# Memorandum

**Re:** Re-submittal of Site Plan, 9610 and 9630 Universe Boulevard NW (PR-2020-004024/SI-2024-00648)

The following memo provides responses to staff comments for the Site Plan Administrative application heard on July 3, 2024. Staff comments are in italic followed by the Applicant responses.

SP-1

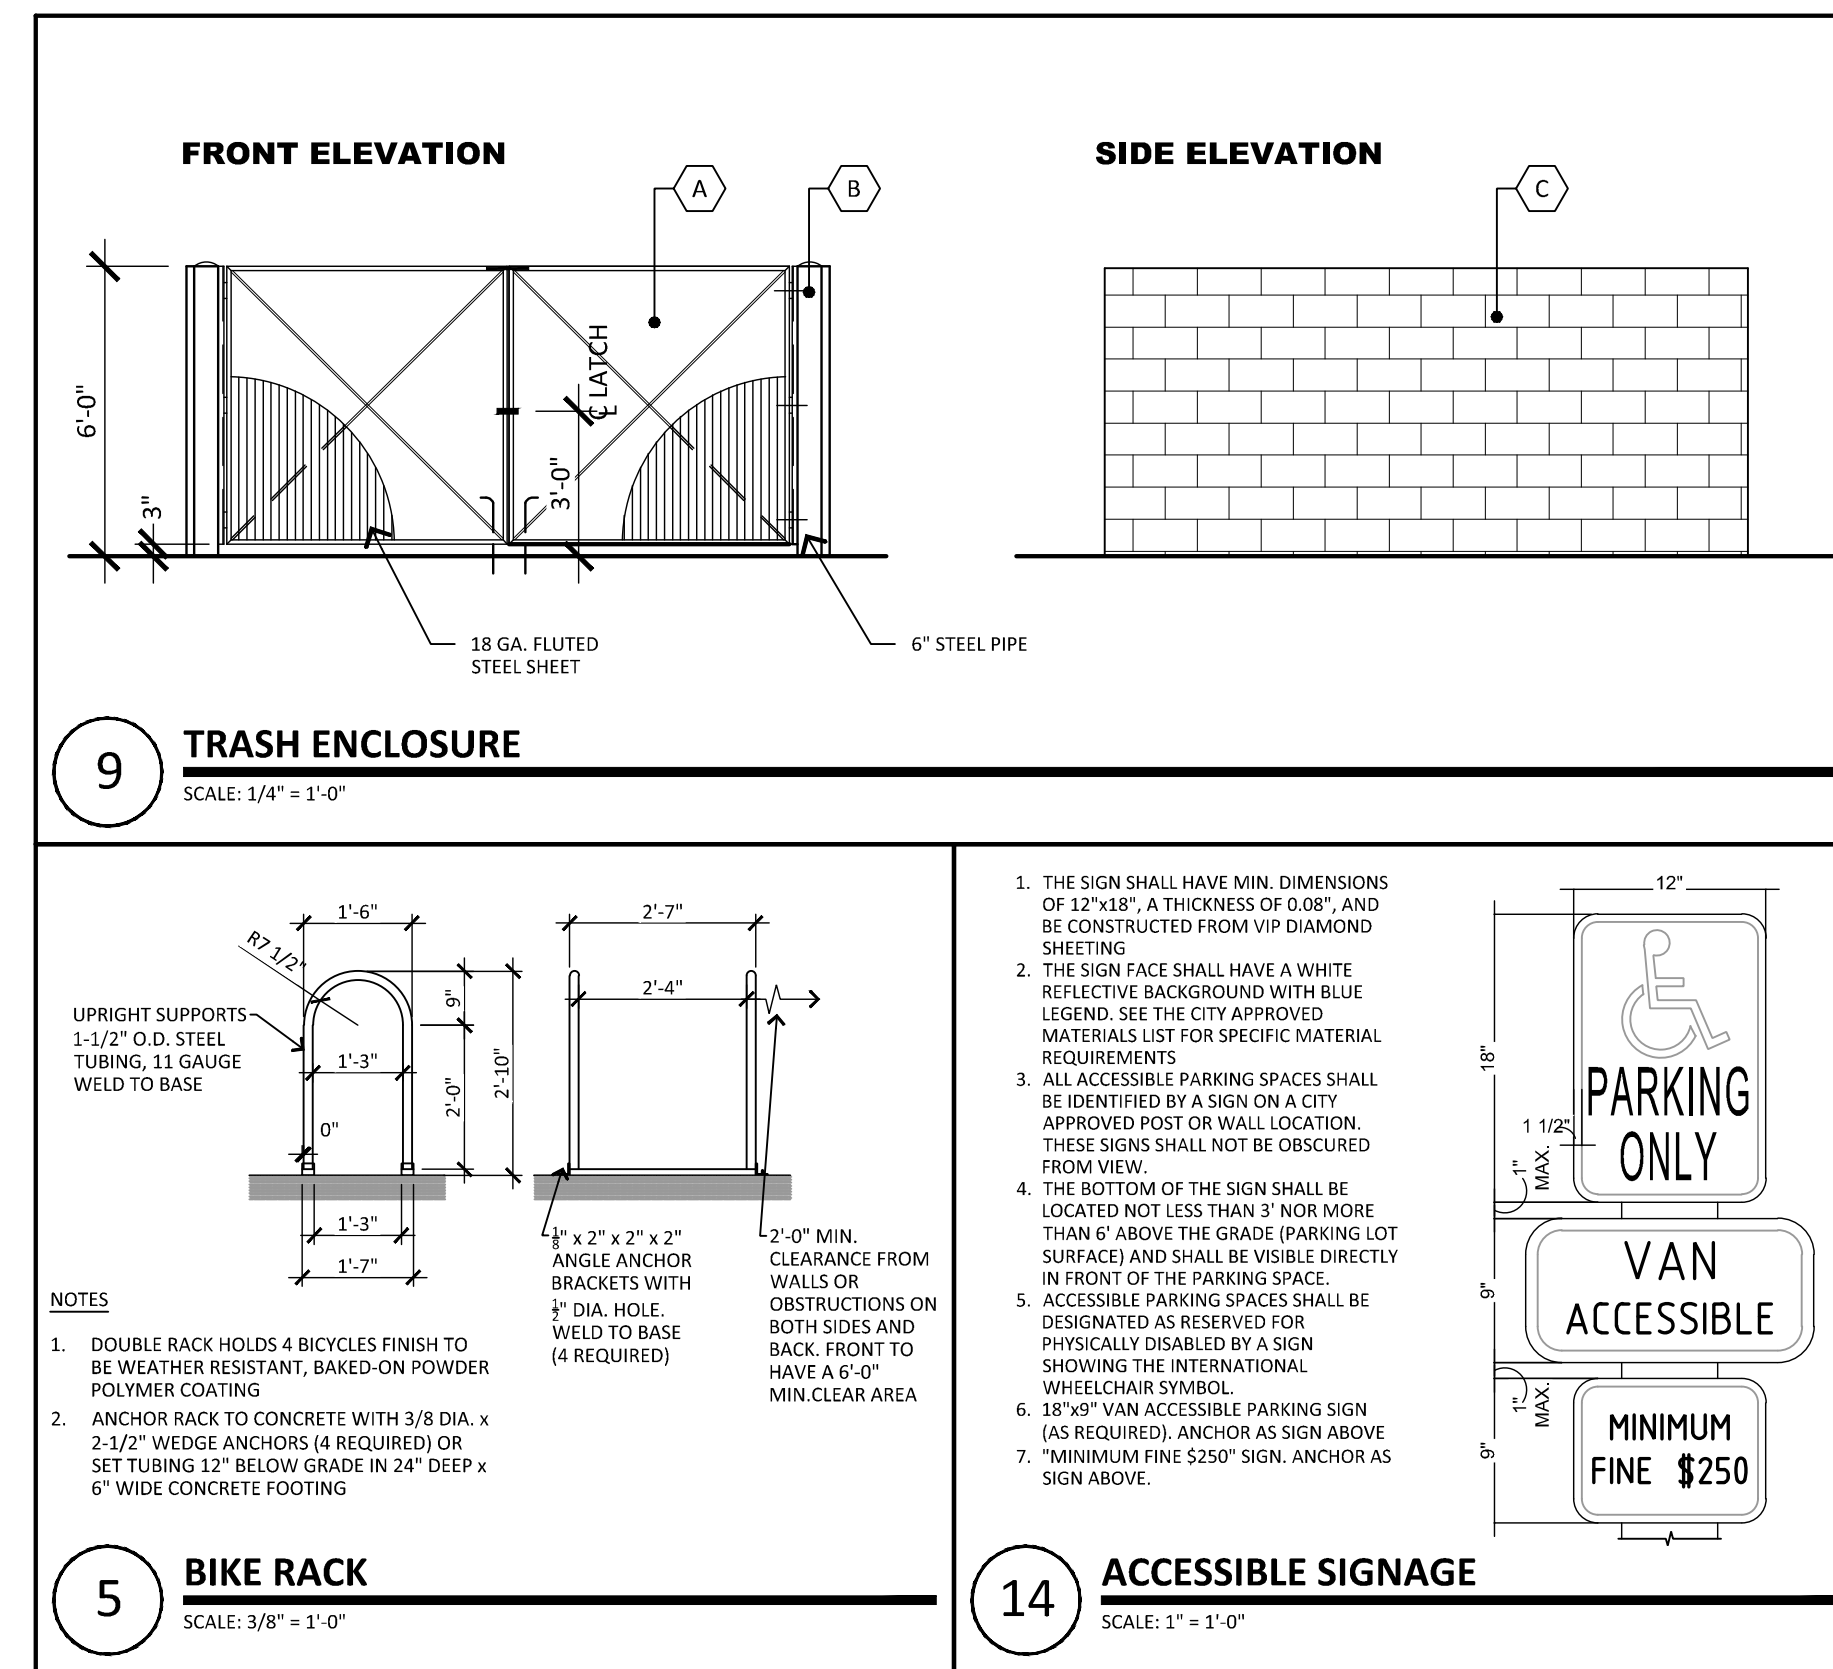
*The project and application numbers must be added to the Site Plan and any associated IL.*

**Applicant Response:** Agreed. The project numbers and application numbers are included on re-submitted plans.

**A1 LANDSCAPE PLAN**

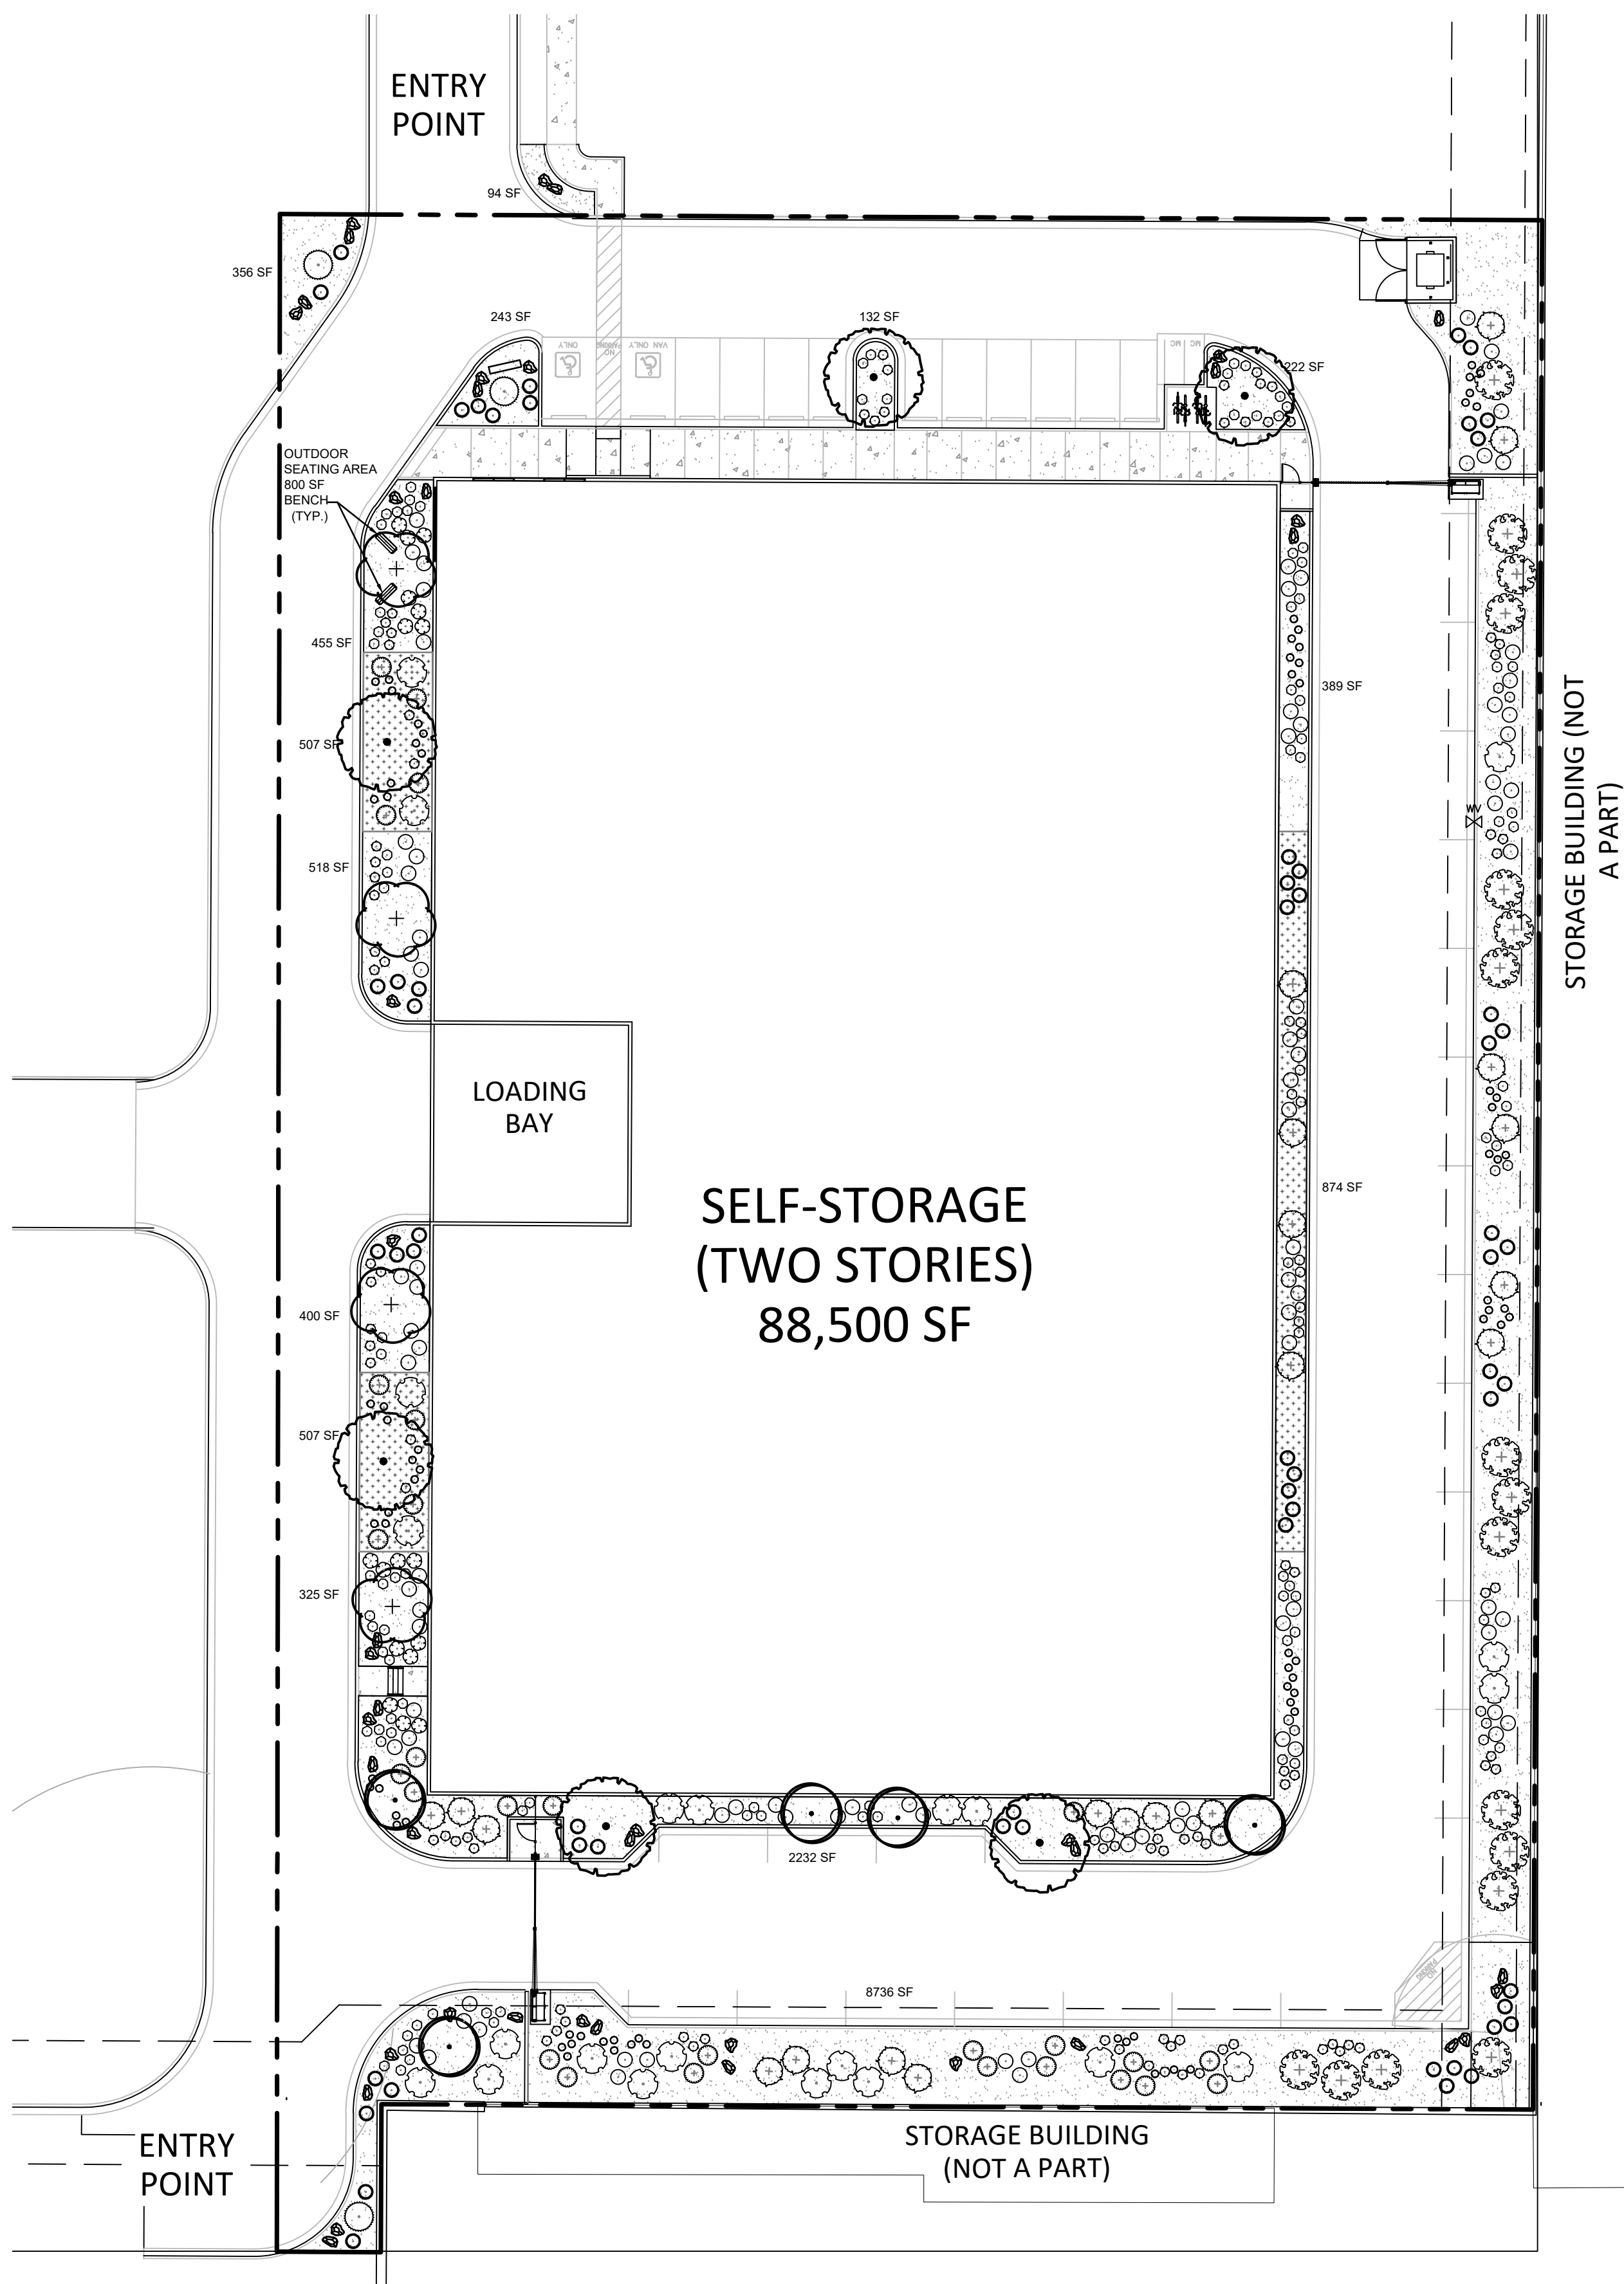
*Pages 6-7: An outdoor seating area is required for a primary building more than 30,000 s.f. per IDO Section 5-11(E)(3)(a).*

**Applicant Response:** The revised Landscape Plan includes 800 square feet of outdoor seating space at the northwest corner of the site, which contains two benches and shade from trees.
